18-076ARB – VESSELS' GARAGE DEMO

The demolition of an existing concrete block garage and brick paver driveway.

Staff Recommendation

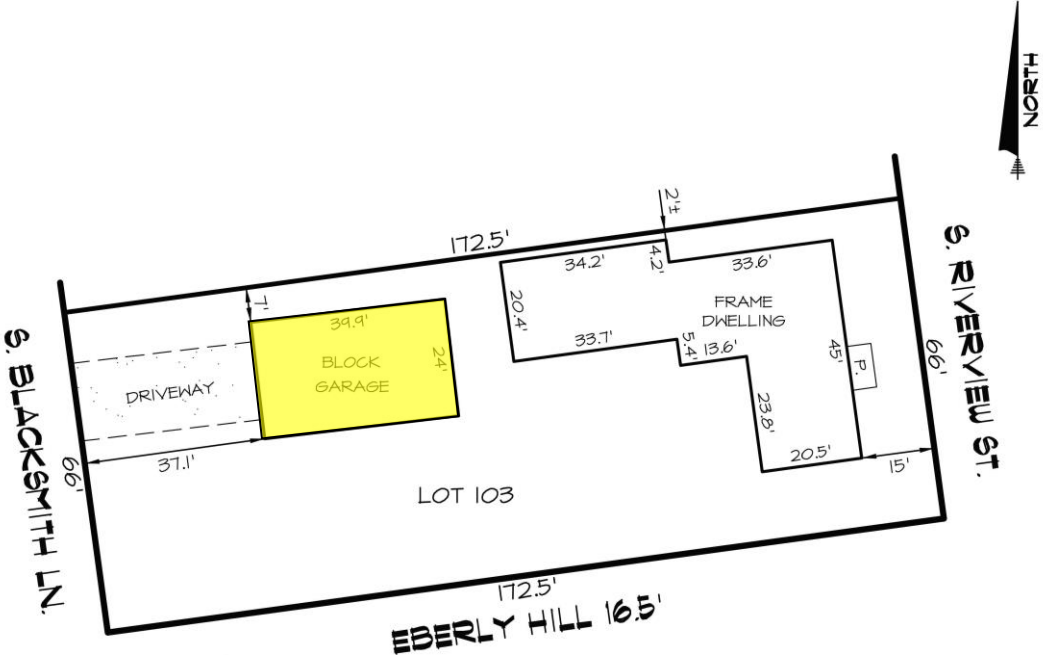
The applicant is proposing to demolish an existing approximately 960-square-foot, one-story concrete block garage and brick paver driveway. The concrete block garage is comprised of a simple gable roof design, three windows on the north and south elevations, two windows and a door on the east elevation (facing the rear of the house), and a single garage door on the west elevation.

The garage was a later addition to the property and constructed in the 1950's. The driveway is comprised of red brick pavers extending from the edge of S. Blacksmith Lane to a concrete apron in front of the garage.
